Non-Standard Torque Requirements

BULLETIN No. 23-006:

Impacted Product Line: All Carriers

Installation: Wheel lift

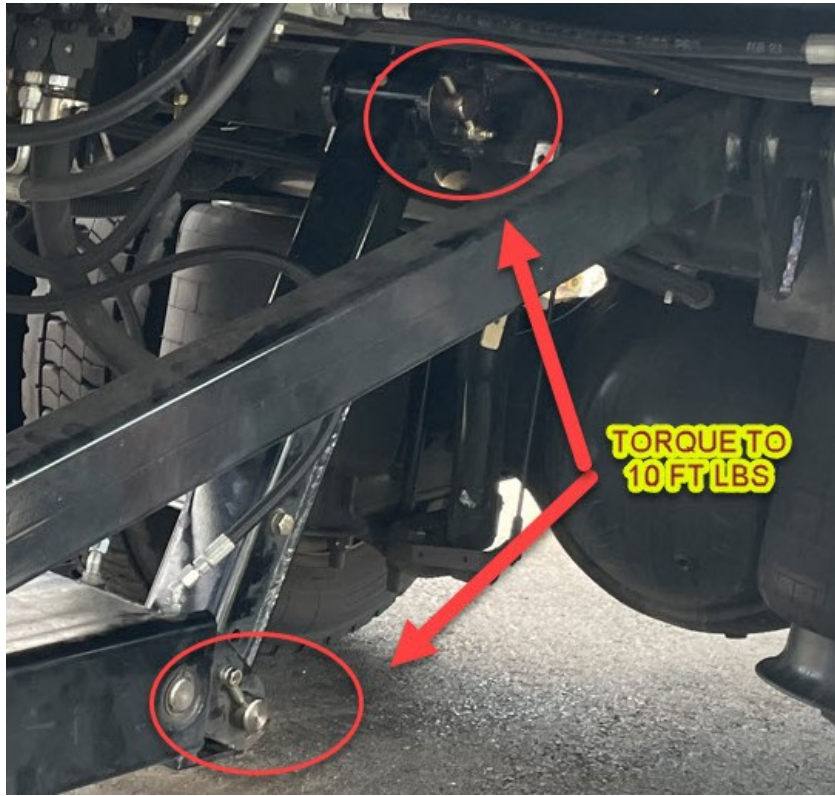
The retaining hardware in the upper and lower adjustable link pivot pin on every carrier wheel lift in your inventory needs to be re-torqued to **10 FT LBS.**

For new carrier wheel lift installations, the upper and lower adjustable link pivot pins should now be torqued to **10 FT LBS.**

This torque requirement is an update to the standard torque applied to this size hardware. All team members working on new installations need to be made aware of this updated requirement and ensure that it is followed.

See pictures below to reference the correct location of the upper and lower link pivot pins.
